DEVELOPMENT APPLICATION ASSESSMENT REPORT

Application Number:	DA2019/1122
----------------------------	-------------

Responsible Officer:	Kent Bull
Land to be developed (Address):	Lot 4 DP 30205, 50 Condoover Street NORTH BALGOWLAH NSW 2093
Proposed Development:	Alterations and additions to a dwelling house
Zoning:	Warringah LEP2011 - Land zoned R2 Low Density Residential
Development Permissible:	Yes
Existing Use Rights:	No
Consent Authority:	Northern Beaches Council
Land and Environment Court Action:	No
Owner:	Shannon Joanna Rose Phoebe Rebecca Rose Charles Rose
Applicant:	Charles Rose

Figure 1. Section A-A showing the extent of the building height breach in red.

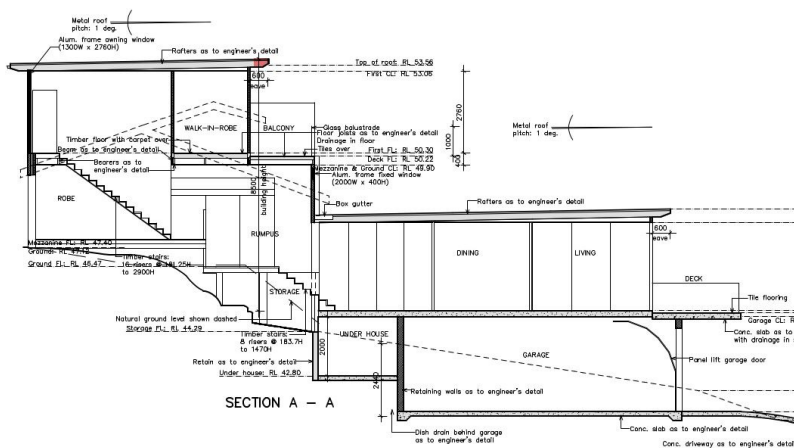
53 Condoover Street, raising concerns that the proposed development breaches the height limit. Based on the plans submitted, the proposed building height is measures at 8.9m, resulting in a 400mm breach to the 8.5m height of building development standard. In this regard, the Applicant has submitted a written request under Clause 4.6 of the Warringah LEP 2011 seeking to justify a contravention of Clause 4.3 Height of Buildings. See Clause 4.6 of the Warringah LEP 2011 for further discussion.

Development standard:	Height of buildings
Requirement:	8.5m
Proposed:	8.9m
Percentage variation to requirement:	4.7%

As such, the applicant's written request has adequately demonstrated that there are sufficient environmental planning grounds to justify contravening the development standard as required by cl 4.6 (3)(b).
